DEVELOPMENT APPLICATION ASSESSMENT REPORT

Application Number:	DA2021/2416
Responsible Officer:	Adam Susko
Land to be developed (Address):	Lot 1 DP 1144798, 155 Pacific Road PALM BEACH NSW 2108
Proposed Development:	Partial demolition of the existing dwelling and the construction of a new dwelling with a detached studio and swimming pool
Zoning:	C4 Environmental Living
Development Permissible:	Yes
Existing Use Rights:	No
Consent Authority:	Northern Beaches Council
Delegation Level:	DDP
Land and Environment Court Action:	No
Owner:	Joanne Robyn Murphy Lambert-Smith Philip Howard Greader
Applicant:	Megan Burns
Application Lodged:	10/01/2022
Integrated Development:	No
Designated Development:	No
State Reporting Category:	Residential - Alterations and additions
Notified:	03/05/2022 to 10/05/2022
Advertised:	Not Advertised
Submissions Received:	9
Clause 4.6 Variation:	Nil
Recommendation:	Approval
Estimated Cost of Works:	\$ 3,428,158.00

Below is 8.5m height plane diagram created by the project architect depicting elements that exceed the plane. The assessment has concluded that the extent of encroachment is appropriately considered 'minor'.

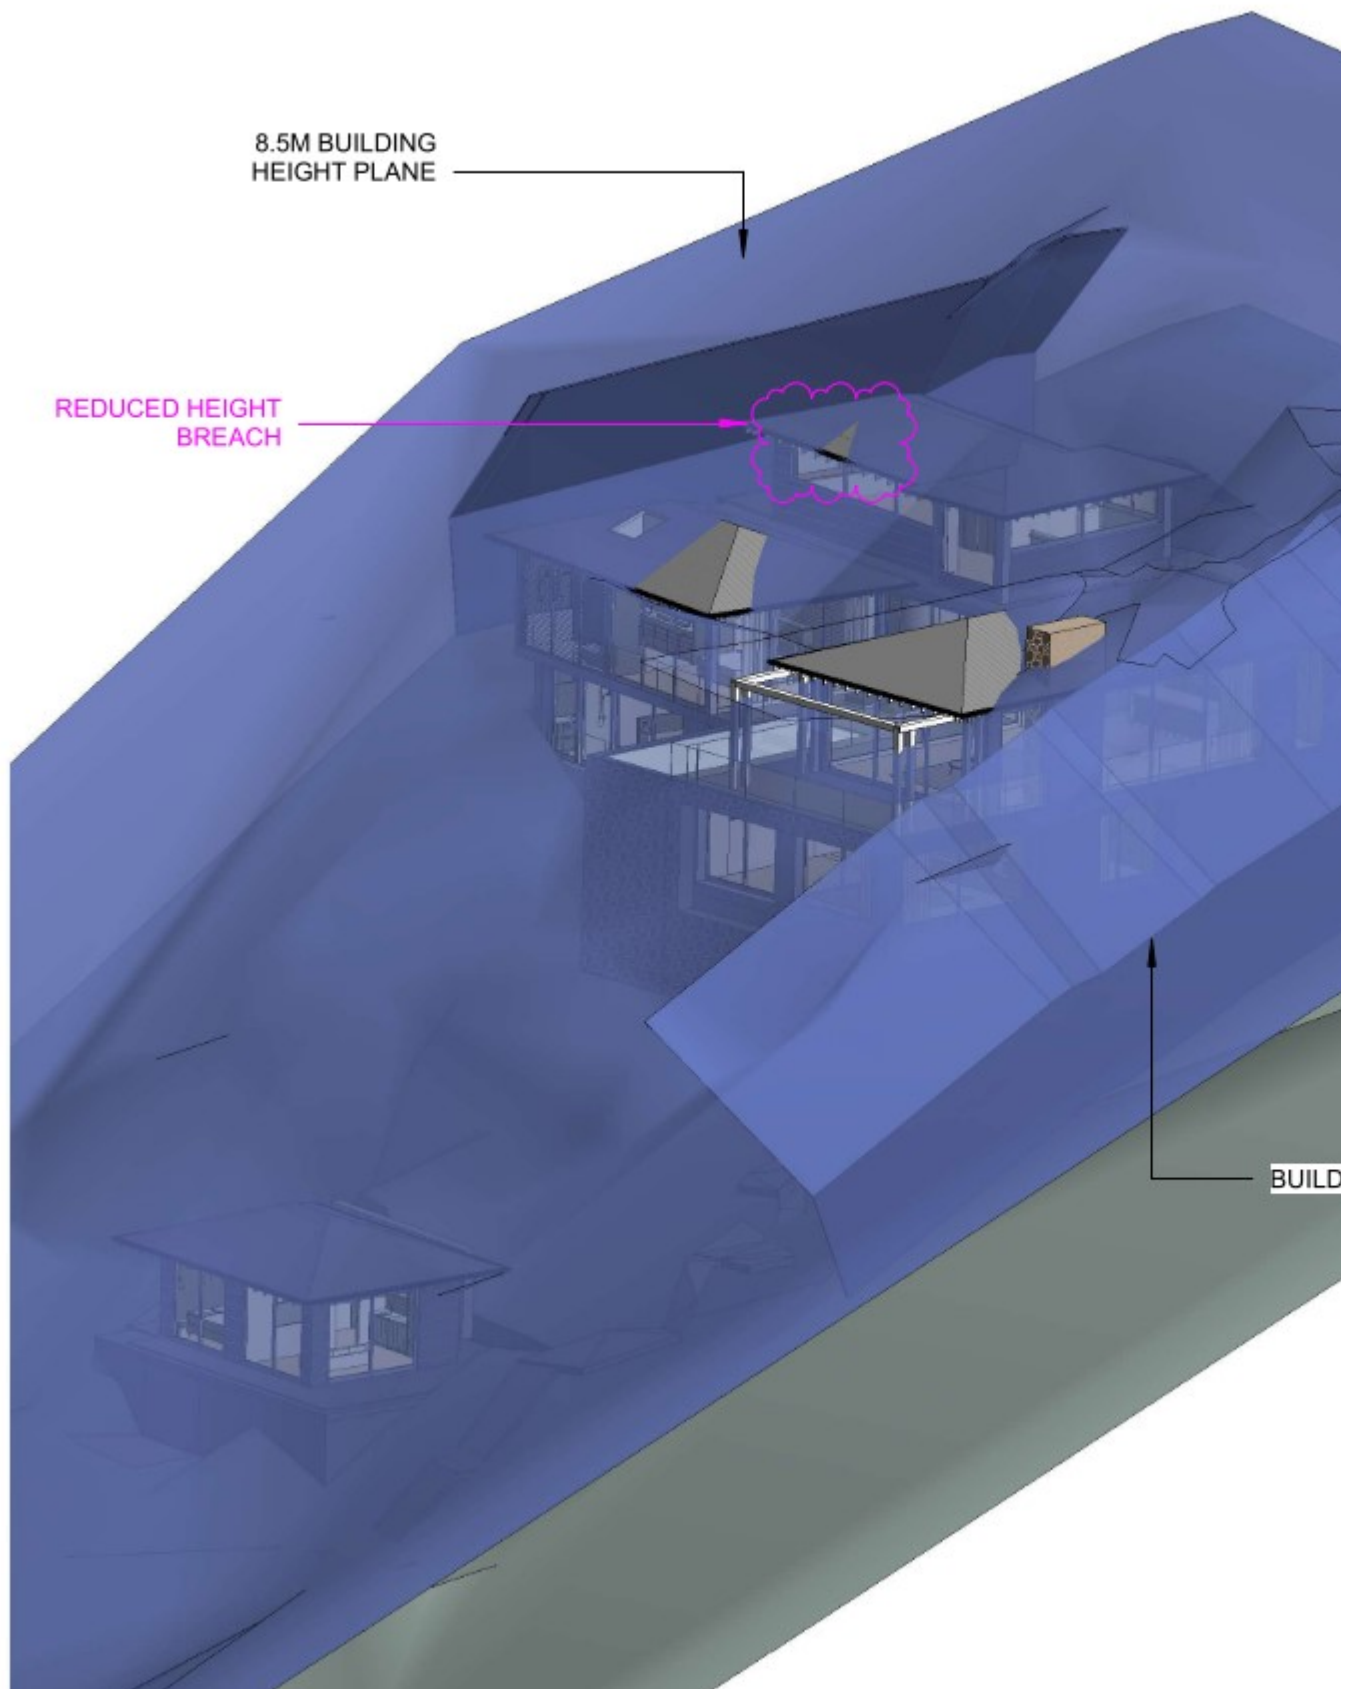
The extent of building encroachment exceeds a 8.5m height plane but is below a 10m height plane. The areas of encroachment are (generally) limited to roof elements, pergolas and a chimney flue.
